Subject: NRC Requests for Additional Information Related to the Audit of the Economic Simplified Boiling Water Reactor (ESBWR) Steam Dryer Design Methodology Supporting Chapter 3 of the ESBWR Design Control Document – GEH Final Responses to RAIs 3.9-285 and 3.9-286

GEH Final Response to RAI 3.9-285

NRC RAI 3.9-285

GEH Final Response to RAI 3.9-286

Figure 4.0: Double sided fillet welded T-joint with nomenclature for analyses

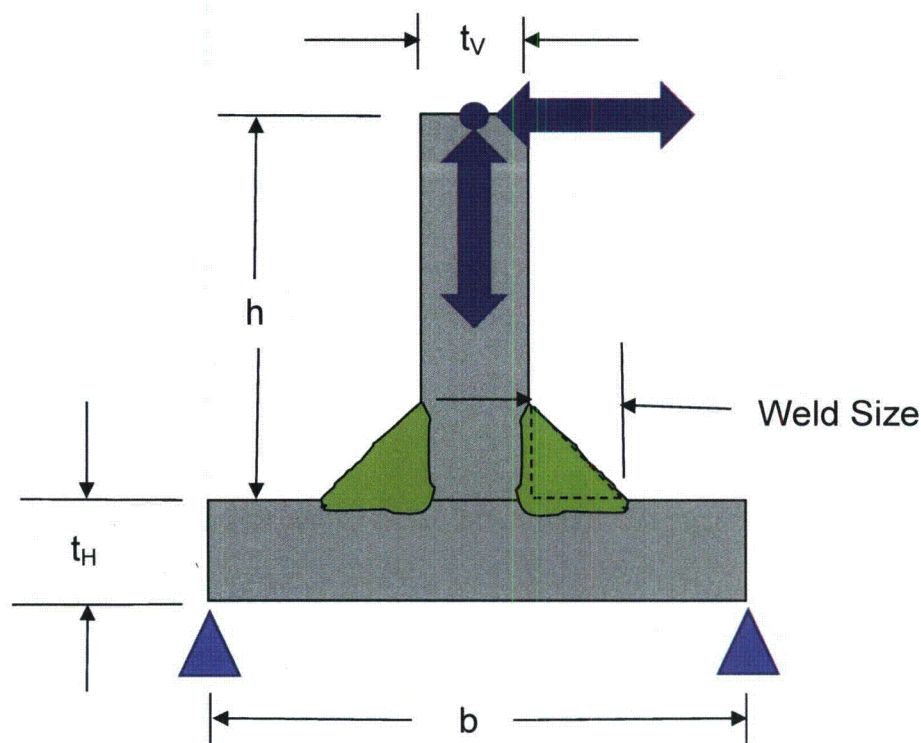
At this time, the staff is seeking a more comprehensive, quantitative technical basis for GEH's conclusion that method (2) provides equal or greater conservatism, compared to method (1). To this end, the staff requests GEH to perform a series of simple confirmatory analyses that the staff can reference in its safety evaluation of this issue. The basic model is a T-connection of 304 stainless steel plates, which may be considered to be of infinite longitudinal length. A unit strip may be used, reducing the problem to 2-D. The basic loading is in-plane membrane force and out-of-plane bending moment applied to the free end of the vertical (web) plate. The horizontal (flange) plate is constrained at both ends.

To provide information to conclude that method (2) provides a more conservative result than method (1) the NRC Staff requested GEH to perform additional analyses. The NRC Staff requested that GEH use a T-joint for the analyses and to reduce the configuration to a 2-D approach. A typical double sided fillet welded T-joint used for ESBWR steam dryer design is shown in Figure 4.0, an ASME B&PV Code Section III NG-3352 Type V weld joint.

The typical T-joint shown in Figure 4.0 is made up of a horizontal continuous member, a vertical stem member, and equal size fillet welds.

Figure 4.0: Double sided fillet welded T-joint with nomenclature for analyses

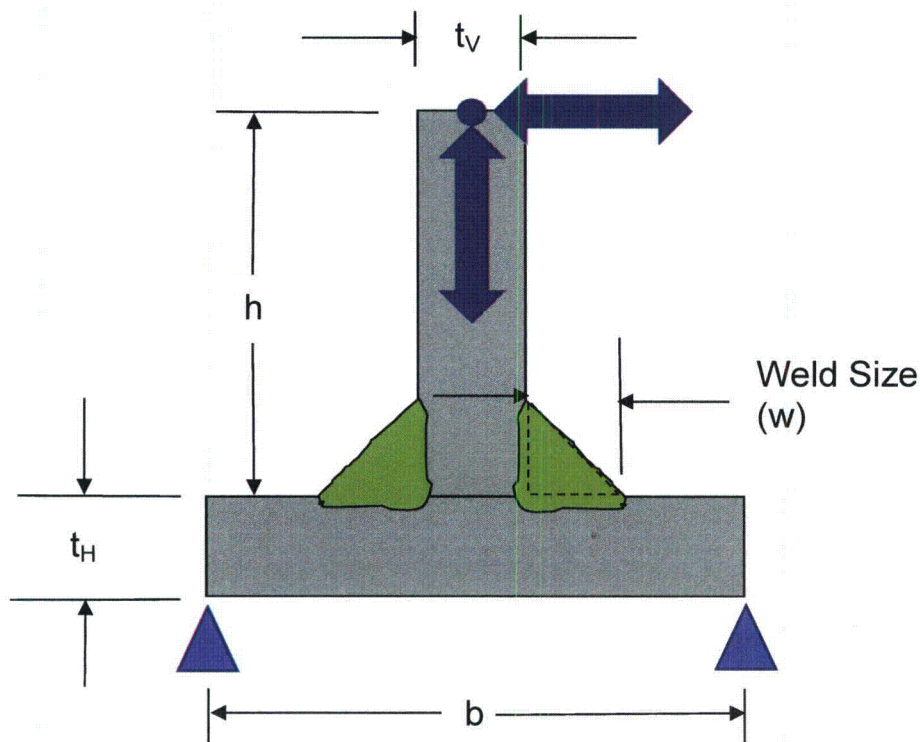
As an adjunct to the parametric study comparing methods (1) and (2) for shell models (see Question 4), the staff requests GEH to develop alternating peak stress intensity predictions using the solid element submodel approach for a representative set of cases, and to compare the results with the corresponding method (1) and method (2) results. Include one example calculation that demonstrates the procedure defined in the statement quoted in the preceding paragraph.

The typical T-joint shown in Figure 4.0 is made up of a horizontal continuous member and a vertical stem member.
